NTB04-052a

## VOLUNTARY RECALL CAMPAIGN POWER SLIDING DOOR LATCH ACTUATOR

**IMPORTANT: THIS BULLETIN HAS BEEN REVISED.**

**CAMPAIGN I.D. # / NHTSA #:** RU401 / 04V-186

Figure 21

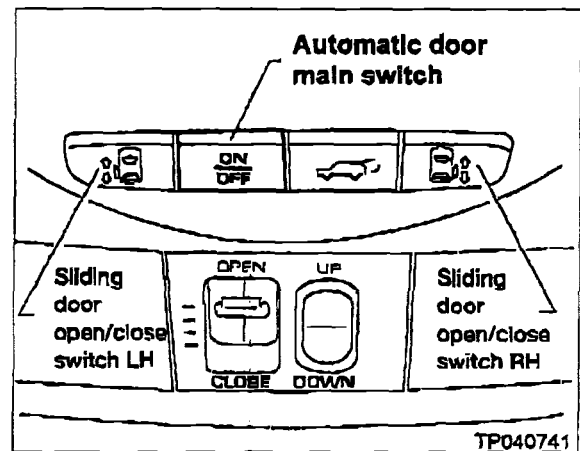
The Power Sliding Door Re-Initialization procedure was revised.

22. Turn the Automatic Door Main Switch OFF (see Figure 21).

Figure 22

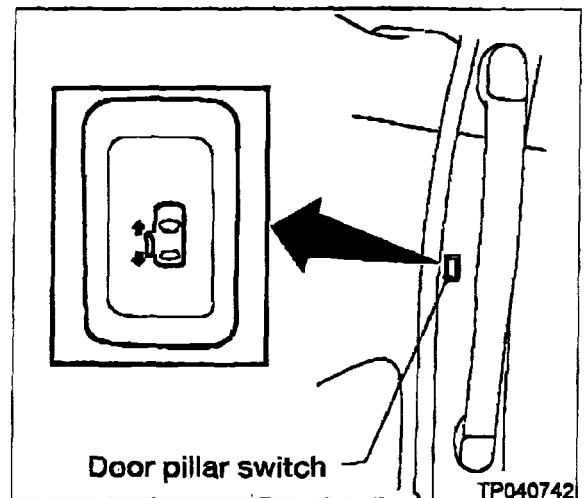
23. Within 3 seconds after step 22, press the sliding door B-pillar switch (LH or RH, depending on which door you are initializing) 10 times within 10 seconds.

Figure 23

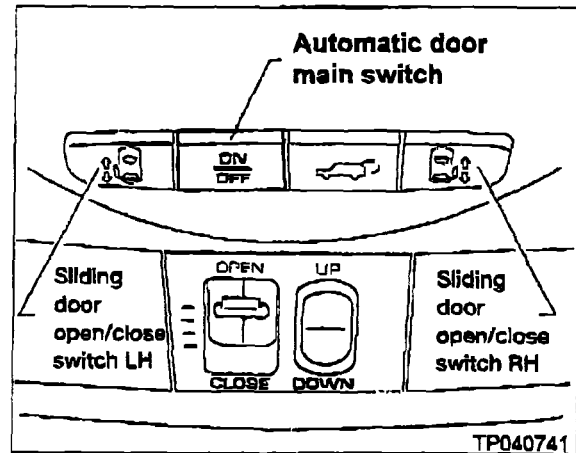
25. Turn the Automatic Door Main Switch ON (see Figure 23).

Figure 24

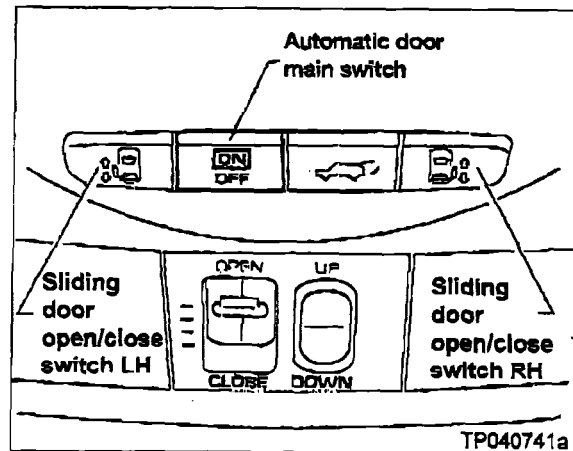
26. Press and hold the driver's overhead Sliding Door Open / Close Switch (LH or RH, depending on which door you are initializing) until the sliding door completely closes and stops; then release the switch.

27. Press and hold the same sliding door switch again, until the door completely opens and stops; then release the switch. (Same switch as step 26.)
28. Press and hold the same switch again, until the door completely closes and stops; then release the switch. (Same switch as step 26 and 27.)
29. Turn the ignition key OFF. One sliding door is now initialized.
- The initialized door will now operate normally.
  - If needed, repeat steps 20 through 29 for a second sliding door.
